**BROWN REYNOLDS WATFORD
ARCHITECTS**

ADDENDUM NO. 03

PROJECT: LOS FRESNOS CITY HALL
LOCATION: LOS FRESNOS, TEXAS
PROJECT NO: 217072.00
DATE: July 11, 2018

The Construction Documents on the above referenced project, dated 6/11/18, shall be revised as follows:

UTILITY PLAN

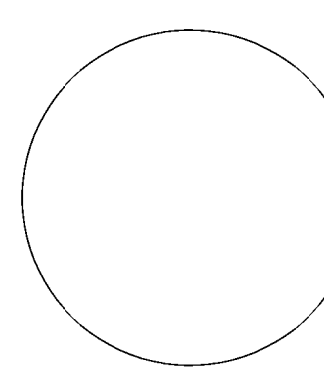
- Item No. 2** (RE: Sheet C2.0, Utility Plan) - The sanitary sewer invert at the building is revised and additional slopes and elevations are noted as shown on attached revised sheet **C2.0**. The invert at the existing sewer tie-in is correct and will require dewatering, as noted in the revised sheet.

△ REVISED SEWER INVERT ELEVATIONS AND SLOPES
ADDED DEWATERING NOTE

S5.0

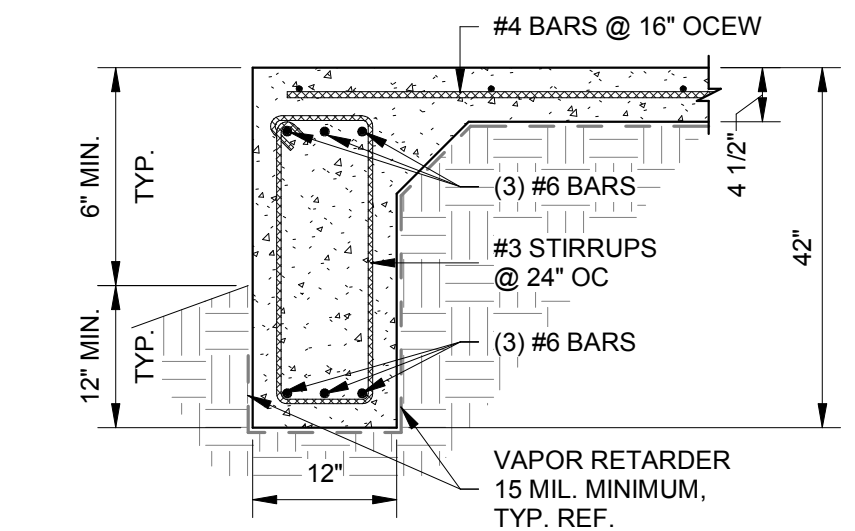
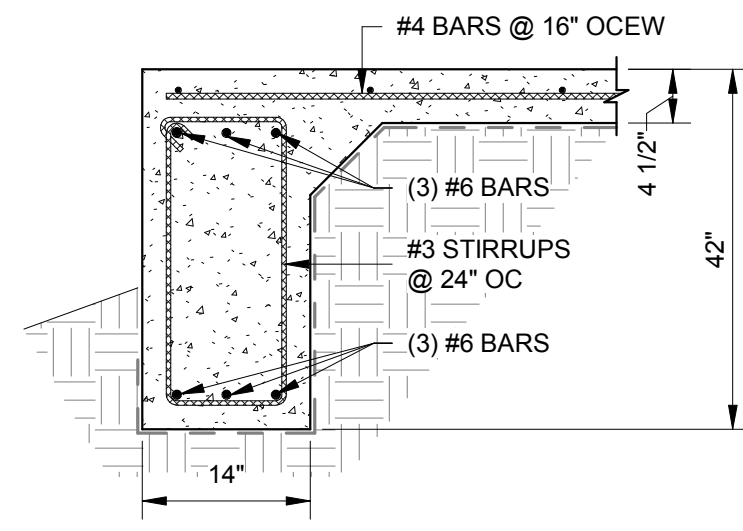
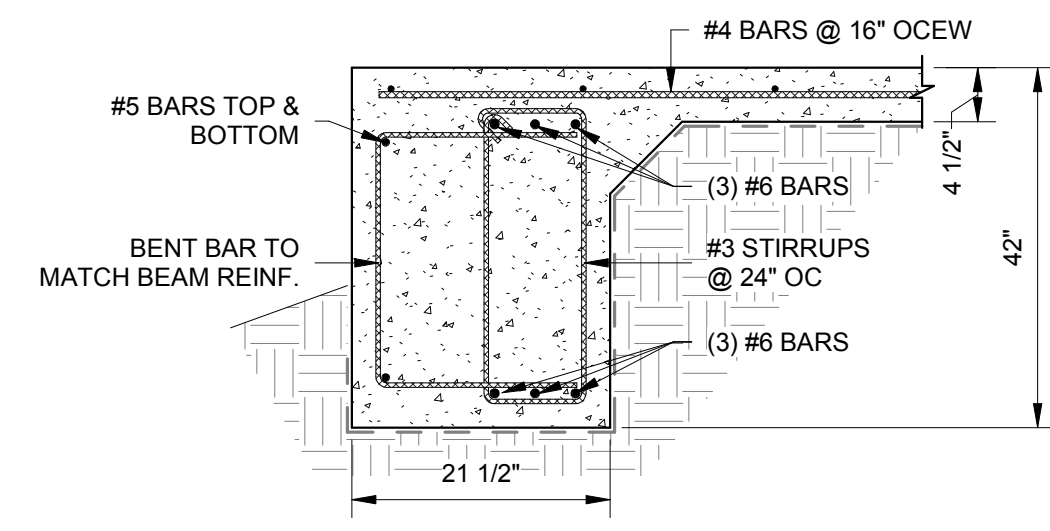
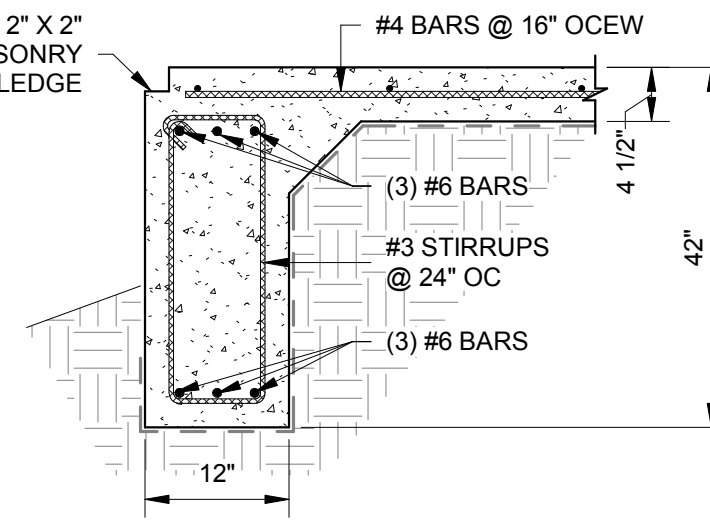
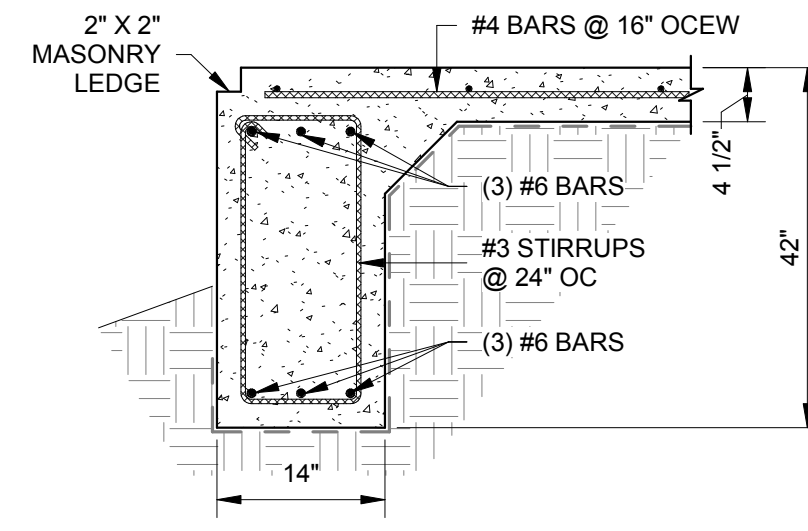
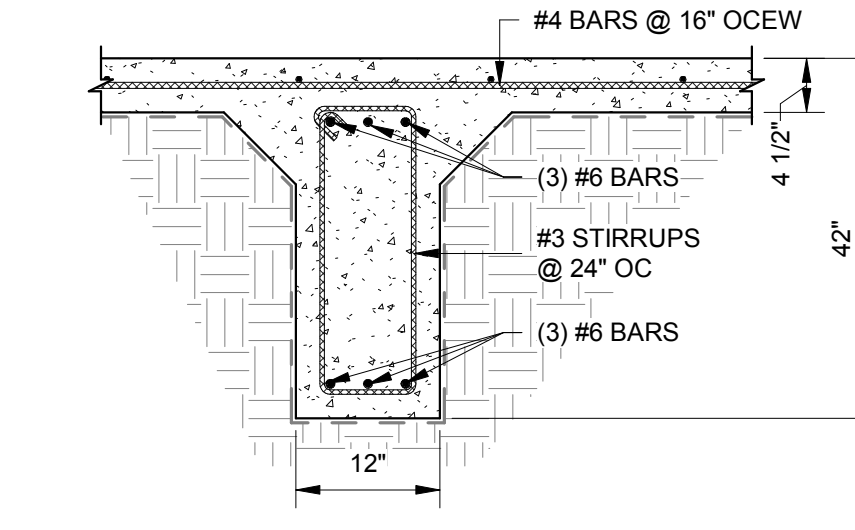
- Item No. 5** (RE: Sheet S1.1, Sheet S5.0) - Callouts for grade beam details are revised as shown in attached revised sheet **S1.1**. Grade beam details are revised and new details added as shown in attached revised sheet **S5.0**.
